Technical Bulletin / Safety Alert

Unique ID No: GEN2008-TBSA-01

Subject: Failed Door Latch Interlock Valve due to incorrect Interlock valve fitted

Applicable to: All JUG-A-0 UL/UV machines

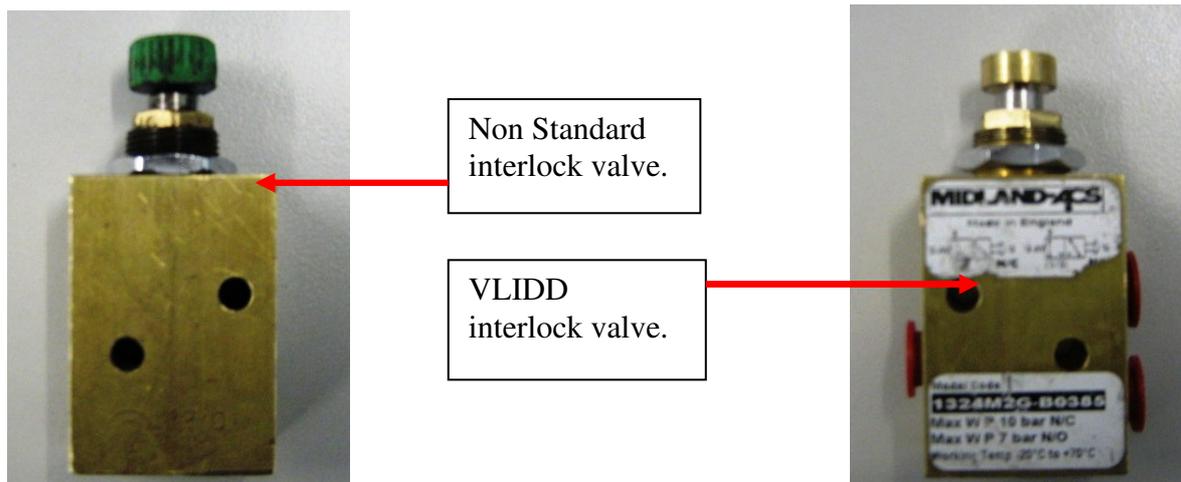
Finally the Door Latch interlock was tested and it was found that if the Latch was unlocked rapidly the air in the Park Brake would not exhaust properly from the exhaust port on the interlock valve. This inturn would cause the Park Brake to remain released.

The first notable item was that the incorrect door interlock valve was fitted to the Door latch. A Non Standard valve had been fitted at some time. The Non Standard valve has a different style plunger on the top compared to the correct VLIDD valve, which when fitted to the Door Latch makes the valve about 4 mm longer. The extra length of the plunger hinders the ability of the valve to exhaust the air from the Park Brake valve.

Also the door interlock valve plunger was riding up out of the heel of the machined recess in the Door Latch pin. This would happen when the plunger travelled through the radius section of the recess.

This would cause the plunger to move into the depressed state, simulating that the Door Latch was closed again. This was evident as a track mark was worn out of the recess on

the outer radius. This only happened when the Door Latch was rapidly moved to the unlatched position.

To correct this fault a new Door Latch assembly and interlock valve was fitted to the machine.

- 1 x Door Latch assembly.
- 1 x Door Latch Plunger assembly.
- 1 x Door Latch Interlock valve.
- Correctly adjusted the valve to exhaust as soon as the plunger drops into the recess.

Only use the correct VLIDD parts when replacing faulty or worn parts.

VLIDD has widened the machining tolerance for the door latch barrel and implement a component change out strategy.
